Re: **Lam TUX**
TIA Supplemental Letter
Project Number 2250180.00

Mackenzie has prepared this supplemental letter to address comments and questions related to and to correct a few items in the revised Traffic Impact Analysis (TIA) dated July 21, 2025, for the proposed laboratory/research and development building, office building, and utility building at the Lam Research campus in Tualatin, Oregon. The updated information does not change the overall analysis and conclusion that the existing transportation system is adequate to accommodate the proposed development with the recommended improvements.

Splits and Phases: 2: SW 124th Avenue & SW Tualatin Road

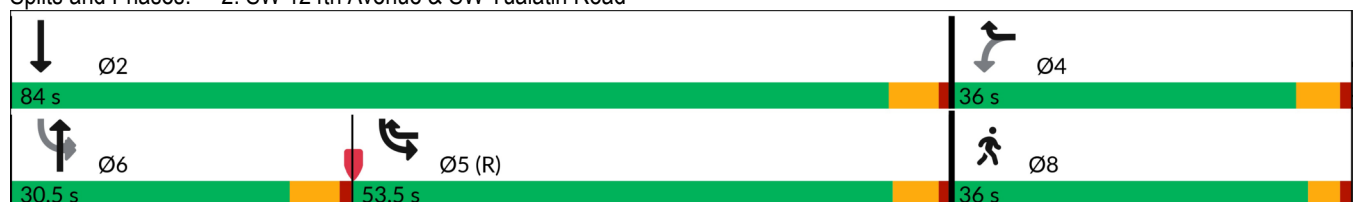
We included a recommendation to coordinate left turn movements from OR 99W to SW Tualatin Road but did not include any analysis showing the benefit. We have since prepared an analysis of the coordination.

Without coordination, the southbound left turn lane queue was found to extend back to the Highway 99W intersection, or about 425' in all scenarios. The TUX project only adds 20 trips to this left turn movement from SW 124th Avenue to Tualatin Road, so volumes don't change much between the scenarios. Vehicles turning left from SW 124th Avenue onto Tualatin Road are primarily arriving from Highway 99W in the southbound (westbound at this intersection) direction. Travel time between the left turn lane stop bars is estimated to be 13-16 seconds.

We found that allowing for a short amount of green time ahead of vehicles arriving allows for queued vehicles to begin clearing the lane first. An offset of 10 seconds between the start of green for these two left turn movements results in the shortened queue of 350' for the AM peak hour, near the effective length of the striped turn lane and better than existing conditions. A queue of 250' is expected in the PM peak hour.

The coordinated queuing results are attached (Attachment A).
